# CHANGES FROM RELEASE 2023-02 TO 2023-03 FOR EOS C VTOL UAV

357-204-101436-01-10

2023-12-20

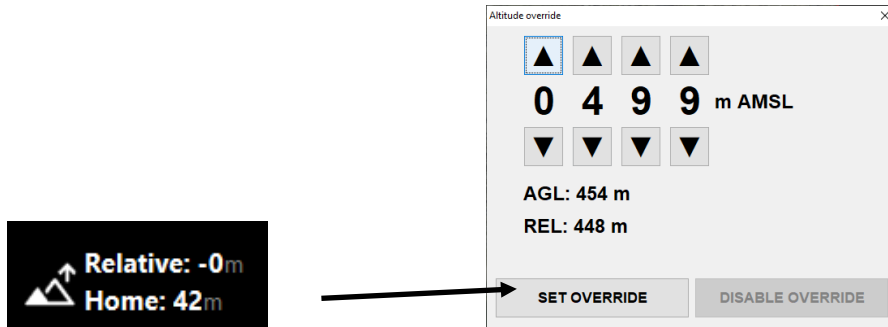
- Status bar user interface changed completely. Status bar is showing GDT and AC radio link now instead of only GDT. Icon is showing if aircraft is in multirotor mode (lift motor circles added as in picture) or fixed-wing mode. Aircraft speed icon changes if manual speed override is active or automatic speed override is active. Speed override icons themselves are same as previously. Notifications buttons icon and border color depend on which is most severe error in notifications window.

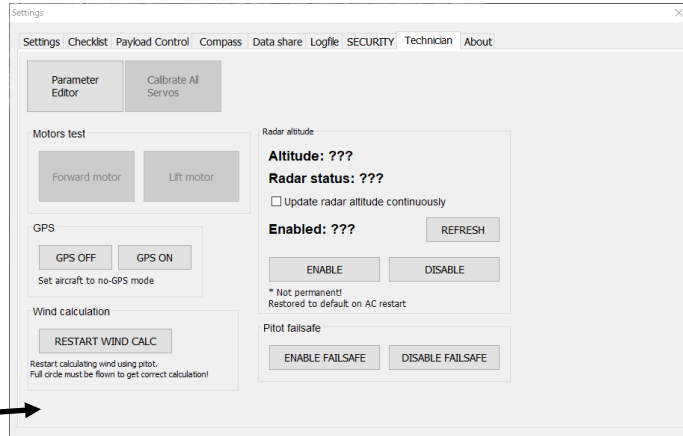
- Altitude override can be additionally opened from status bar (altitude bar still works as it did before).

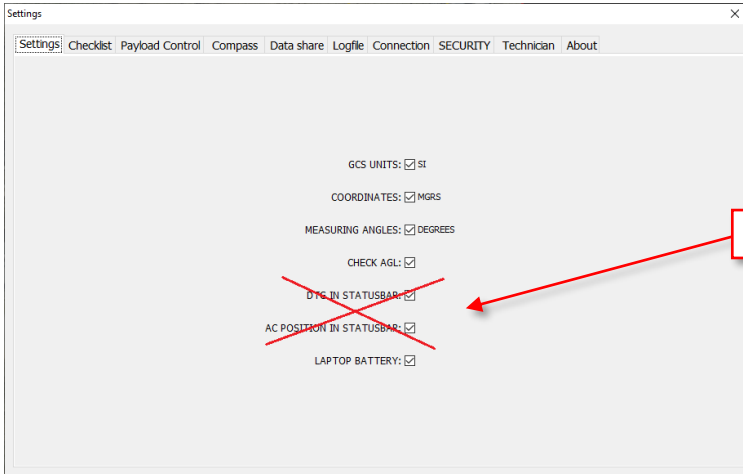
- GPS icon on the status bar acts as a shortcut. Clicking on GPS icon opens Settings window tab where you can turn GPS ON/OFF.

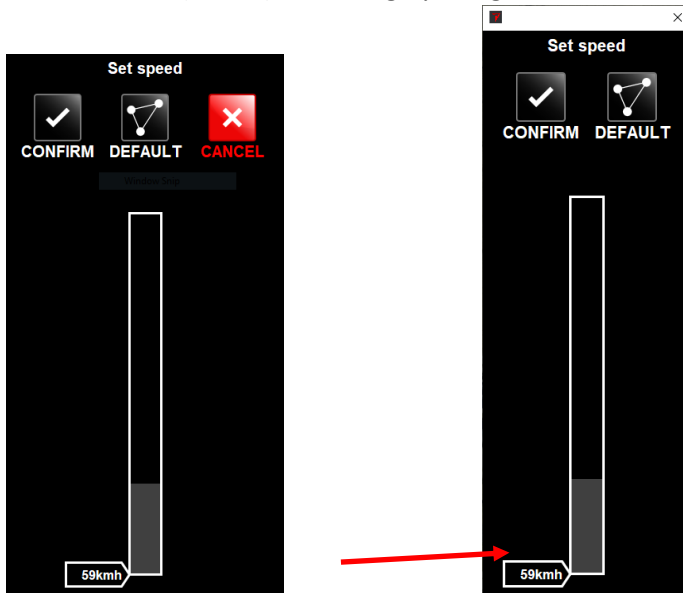
- Coordinate and DTG options have been removed from settings as it's not needed to show them in status bar (already visible in video overlay).

Deleted these two checkboxes

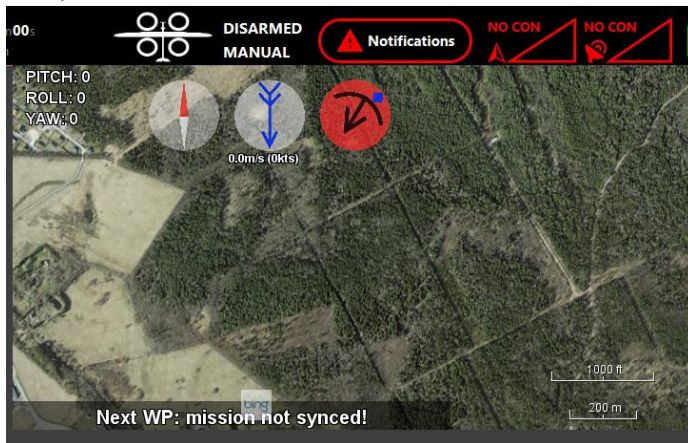
- Now, the speed override dialog can be dragged, and the red "cancel" button has been removed. You can now close (cancel) the dialog by using the default Windows close button.

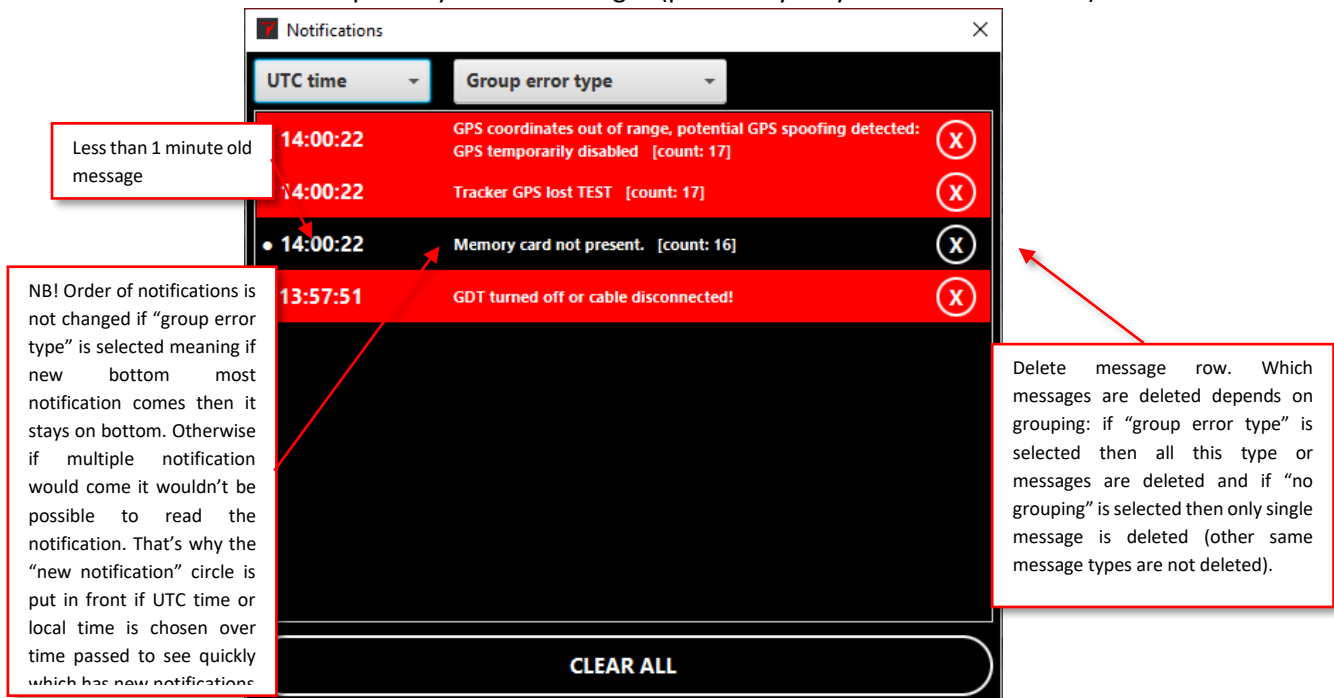
- Wind indicator icon is blinking if UAV is in pitot failsafe mode.
- If GPS part is blinking as error in status bar (no 3D fix, not enough satellites or using GPS in autopilot is turned off) then it's showing best satellite count in brackets. Best satellite count means it shows highest satellite count of the different existing GPS devices (if multiple) which match criteria: have 3D fix, barometric altitude and GPS altitude difference is less than 1000m and last telemetry received for given GPS is less than 4 seconds ago. Useful if you fly in GPS denied area and fly back and want to know if/when to turn back on GPS usage in autopilot instead of flying with INS.

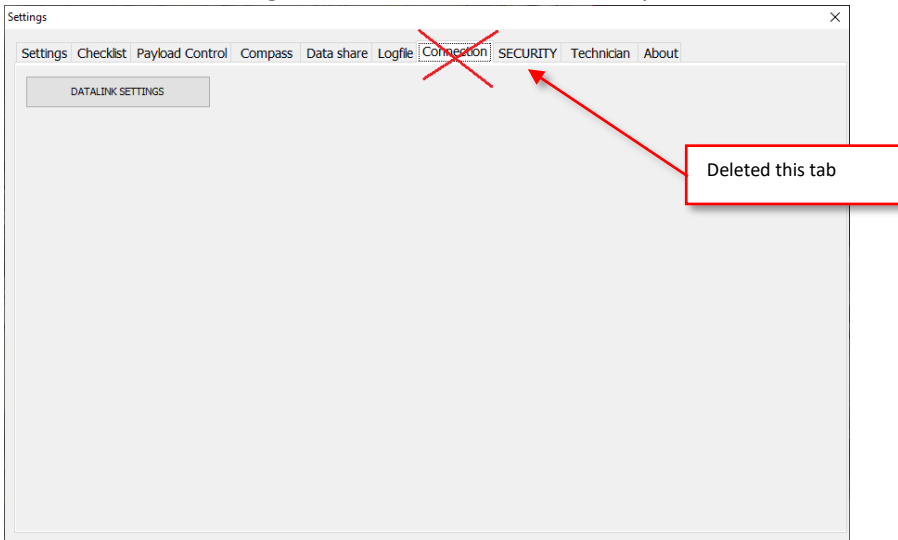
- Errors window UI changed completely. Now it's possible to set which time is shown for errors (UTC, local time, time passed) and how errors are grouped (error type, consecutive type, no grouping). If UTC or local time is selected then circle is shown next to time that tells this message is less than 1 minute old.

NB! Order of notifications is not changed if "group error type" is selected meaning if new bottom most notification comes then it stays on bottom. Otherwise if multiple notification would come it wouldn't be possible to read the notification. That's why the "new notification" circle is put in front if UTC time or local time is chosen over time passed to see quickly which has new notifications

Delete message row. Which messages are deleted depends on grouping: if "group error type" is selected then all this type or messages are deleted and if "no grouping" is selected then only single message is deleted (other same message types are not deleted).

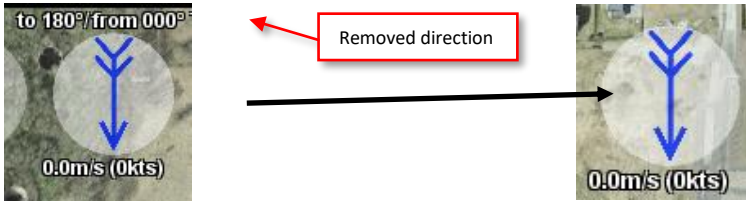
- The text on the pitot failsafe buttons has been updated for better clarity: 'FAILSAFE ON' is now 'ENABLE FAILSAFE', and 'FAILSAFE OFF' has been changed to 'DISABLE FAILSAFE'.
- Changed error view that is showing more serious errors on top-center of window. Now you can mute the error sound for all currently visible errors. If new type of error appears the error sound will play again. If you clear the notifications list in notifications window and same error appears again the error sound will also play again. You can remove some errors separately from the error view. If you clear the notifications list in notifications window and the same error (removed from errors view) appears again then it'll appear in errors view again also. Now it's showing error description if it comes from autopilot (previously it showed just 'error in component X').

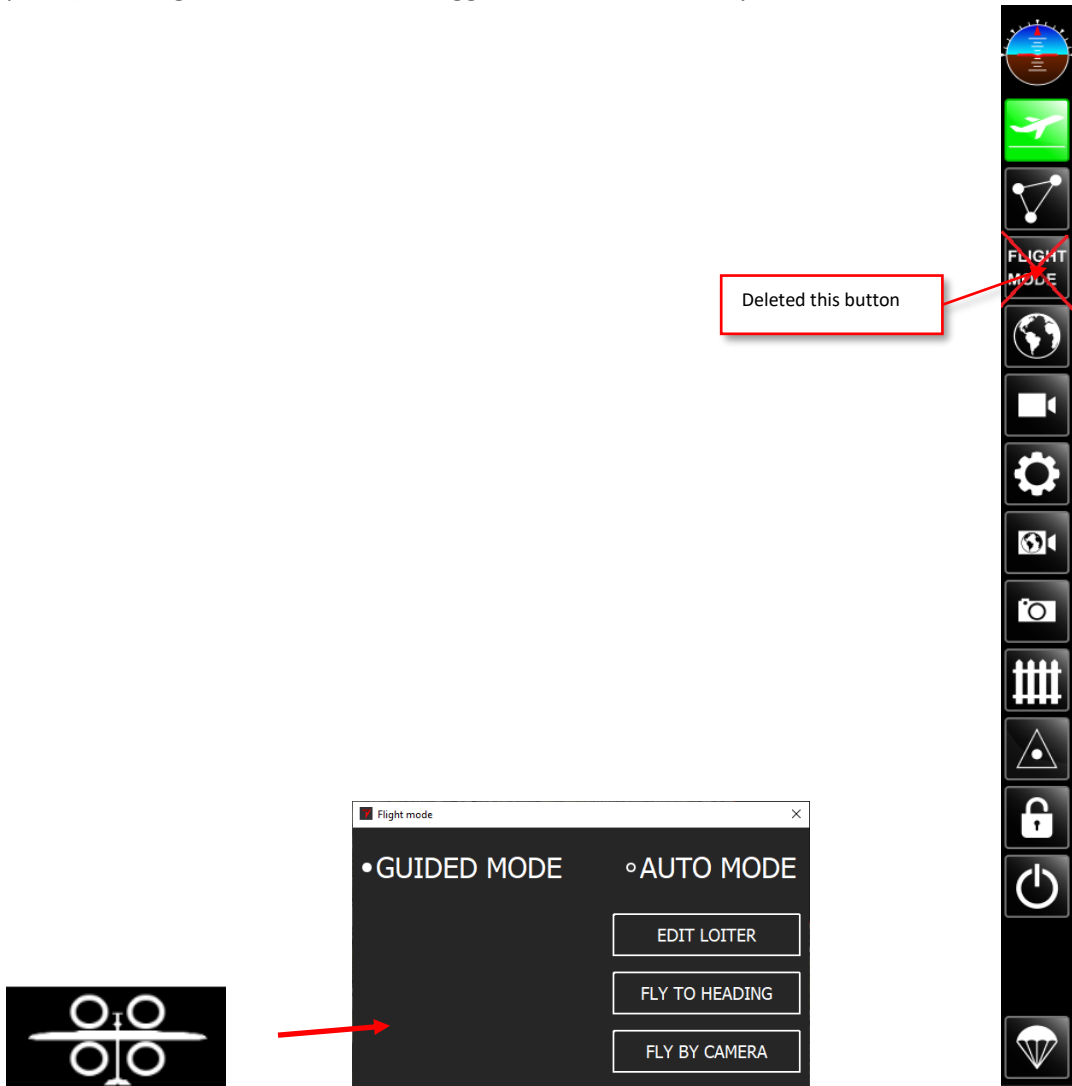
- When switching back to auto mode then next time you switch to guided mode the speed is reset to default speed (if it was increased in guided flight).

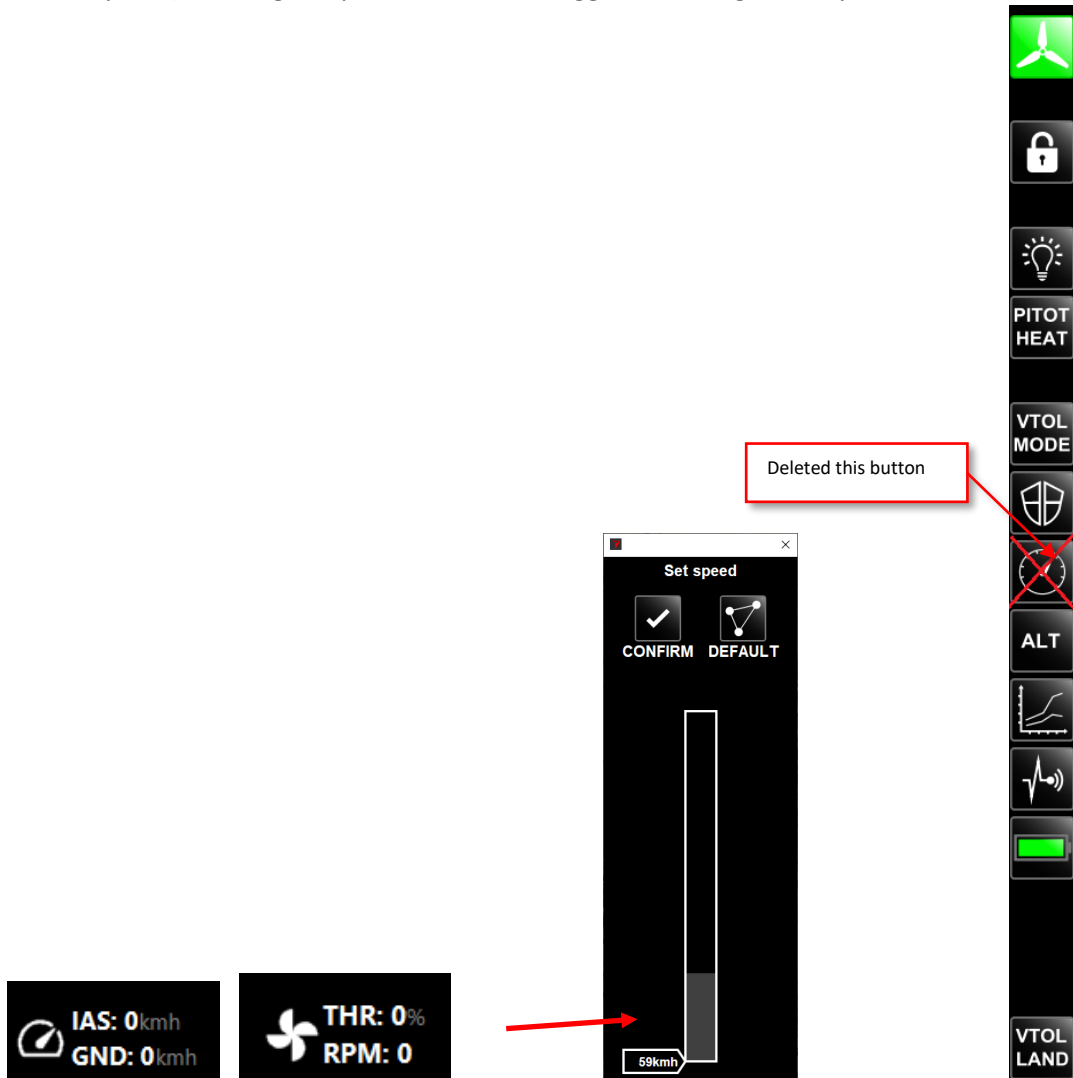
- Flight mode dialog is opened from status bar now (removed flight mode button from left buttons panel). Clicking on aircraft icon will toggle the window visibility.

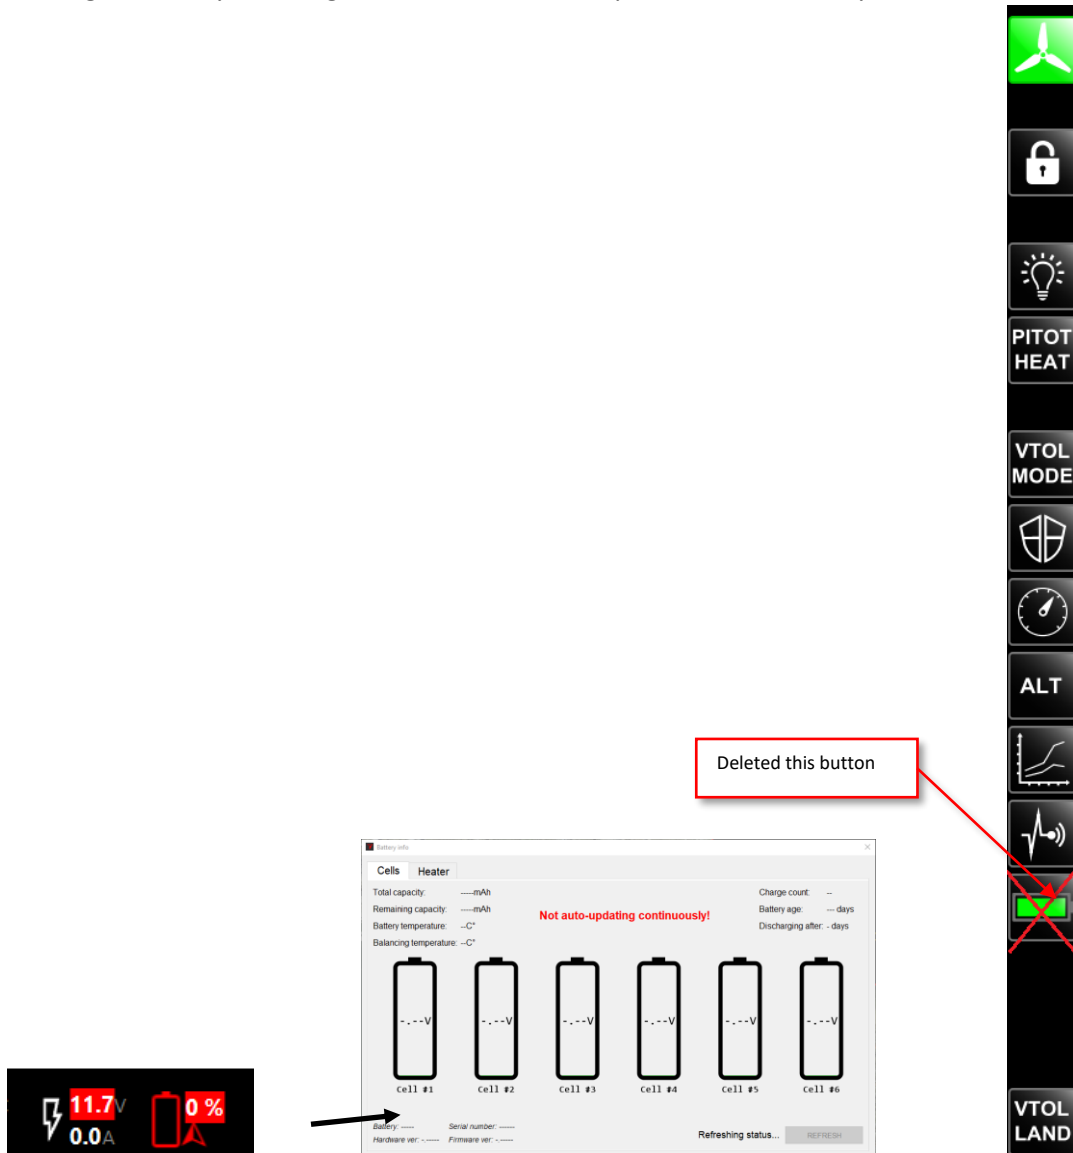
- Speed override dialog is opened from status bar now (removed speed override button from flight buttons panel). Clicking on speed section will toggle the dialog visibility

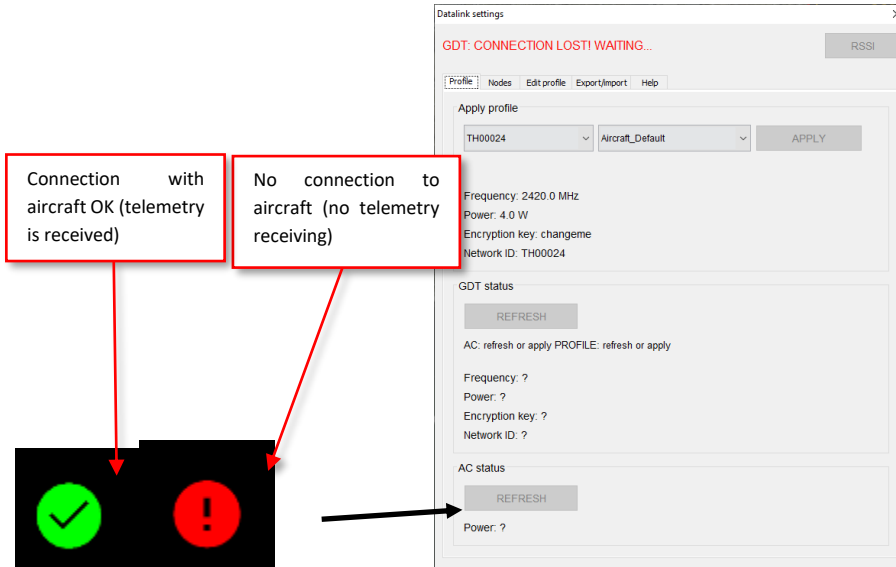
- Charge count value of heated batteries was not working properly – system was showing random numbers. This issue is not fully resolved, so instead battery cycle count for heated batteries is now shown as 'N/A'.
- Radio aircraft profiles window can be opened directly from status bar (telemetry status icon - most left icon on status bar). It can still be opened also from radio connections window as previously.

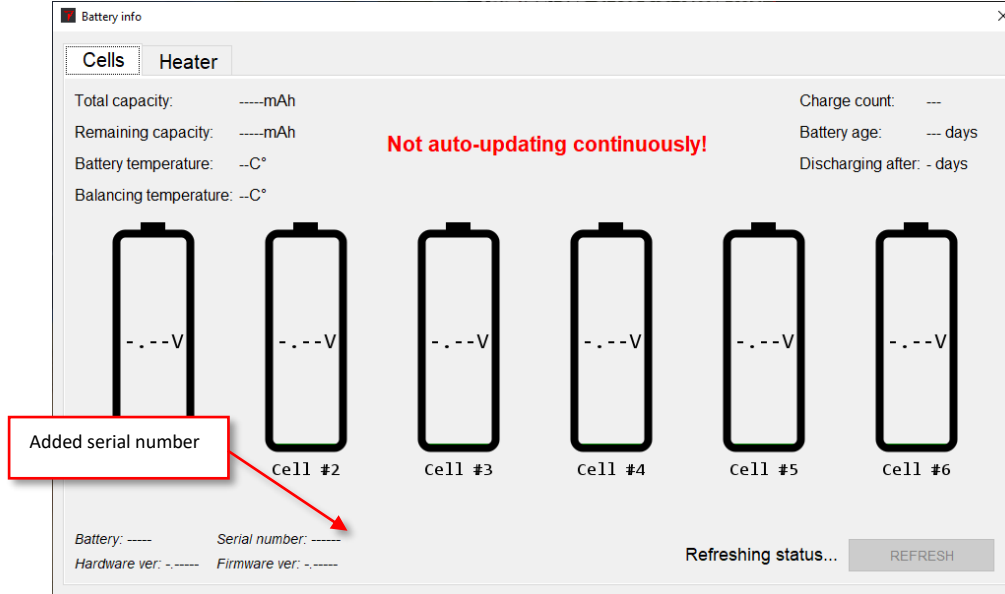
- Will show text '(FAILSAFE, INACCURATE!)' next to playtime if UAV is in pitot failsafe mode currently

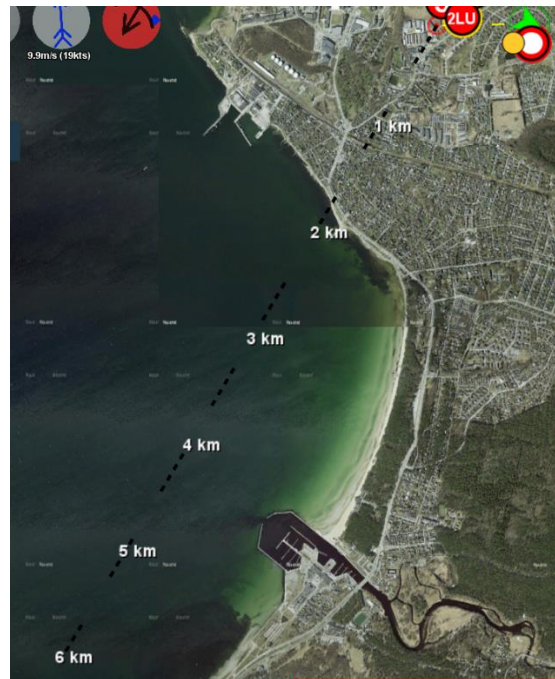
- Battery serial number shown in battery window.

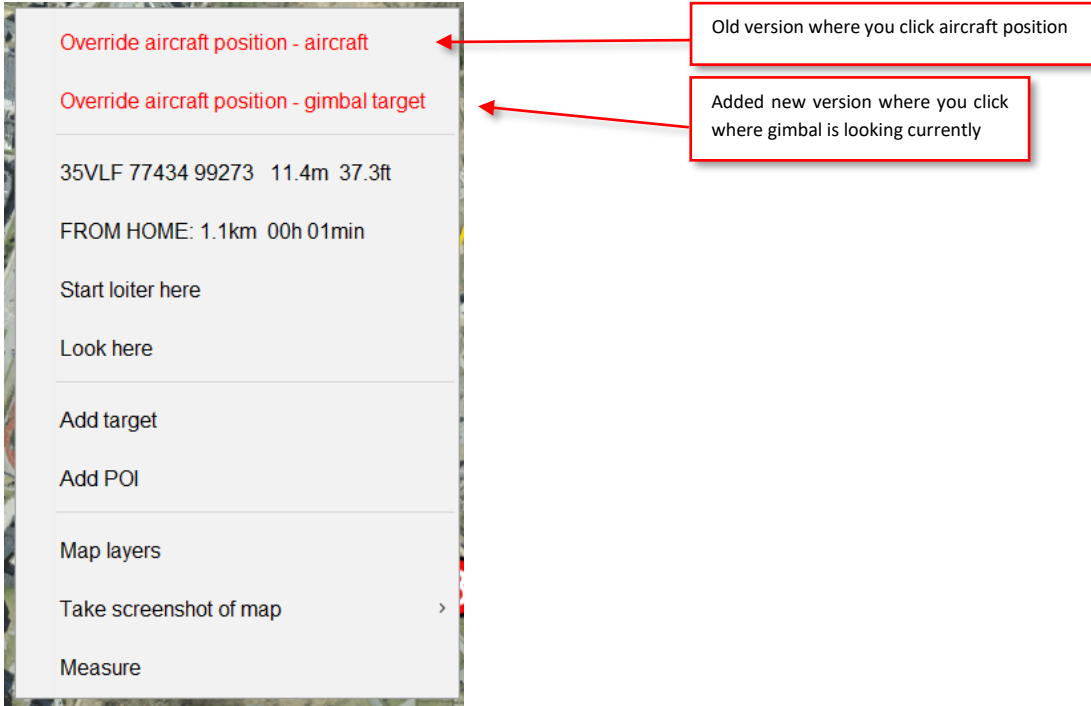
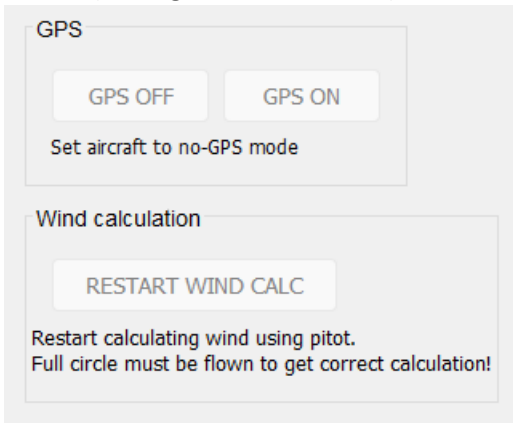
- Aircraft position can be overridden (no GPS flight) by using gimbal target now. Map context menu has option 'Override aircraft position - gimbal target' which tells where gimbal is currently pointing and

calculates aircraft position from this. Old 'Override aircraft position' option changed to 'Override aircraft position - aircraft'.

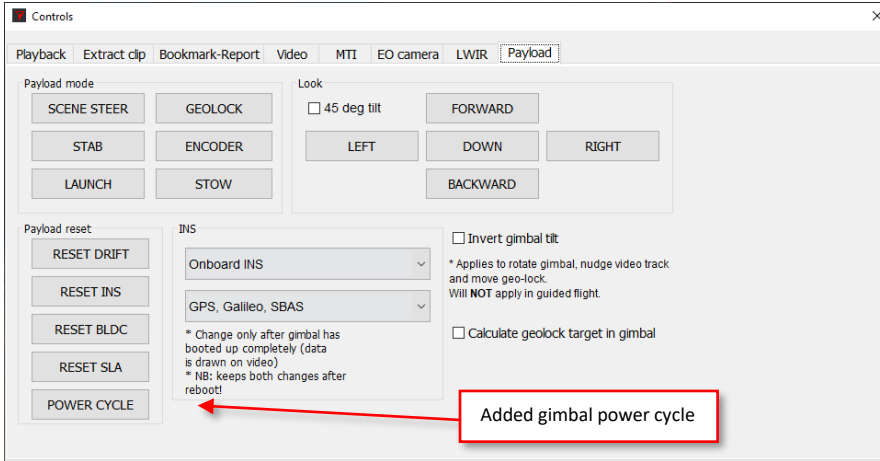
**Important note!** Autopilot no longer updates wind speed and direction after GPS has been turned OFF. When GPS signal receiving is turned back ON, then “Restart wind calculation” must be activated as well (Settings->Technician tab).
